# Access Compliance Report

### (Curb Ramps)

Intersection ID: 44770	Main Street: KINGS_PARADE_BV	Cross Street: OBAN_PASSAGE_DR	Location: NE
ADA ID: 2ED42B2332A6	Ramp Type: PerpDiag	Initial Pass/Fail: Fail	Overall Compliance: No
Severity Score: 10			
Codes/Mitigation Info/Possible Solution		Field Measurements/Component Compliance

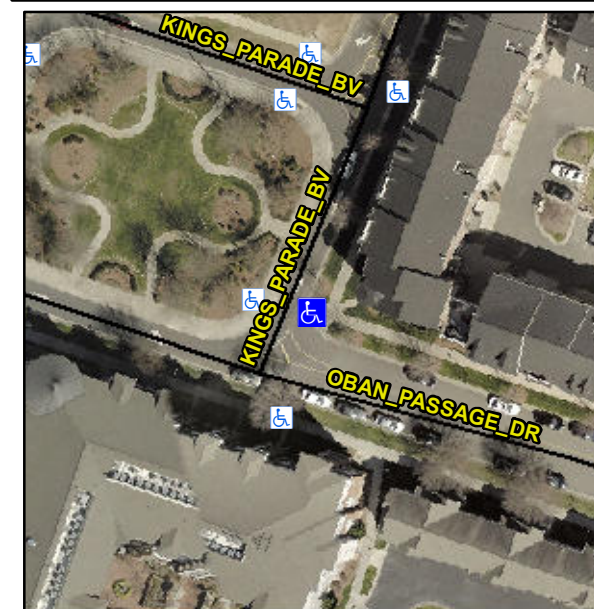
**Remove & Replace Curb Ramp With Two New Directional Ramps or Equivalent.**

**R304.5.1, R304.5.3**

Compliance	Description	Data	Compliance	Description	Data
N/A	Ramp Length (in)	97.5	Yes	Ramp Slope (%)	6.1
No	Ramp Width (in)	47.0	No	Ramp XSlope (%)	4.9
N/A	Flare Type LT	N/A	N/A	Flare Type RT	N/A
N/A	Flare Slope LT (%)	N/A	N/A	Flare Slope RT (%)	N/A
N/A	Flare Traversable LT?	N/A	N/A	Flare Traversable RT?	N/A
N/A	Landing Length (in)	N/A	N/A	DWS Provided?	N/A
N/A	Landing Width (in)	N/A	N/A	DWS Contrast?	N/A
N/A	Landing Slope (%)	N/A	N/A	DWS Length (in)	N/A
N/A	Landing X Slope (%)	N/A	N/A	DWS Full Width?	N/A
N/A	Landing Curb? (Y/N)	N/A	N/A	DWS Offset (in)	N/A
N/A	Shared Landing?	N/A			
N/A	Gutter Ponding?	N/A	N/A	Gutter Slope (%)	N/A
N/A	Gutter Lip Ht (in)	N/A	N/A	Gutter X Slope (%)	N/A
N/A	Painted X Walk1?	No	N/A	Painted X Walk2?	No
	X Walk 1 Direction	To W		X Walk 2 Direction	To S
N/A	X Walk 1 Width (in)	N/A	N/A	X Walk 2 Width (in)	N/A
	X Walk 1 Slope (%)	6.1		X Walk 2 Slope (%)	1.4
	X Walk 1 X Slope (%)	2.7		X Walk 2 X Slope (%)	4.0
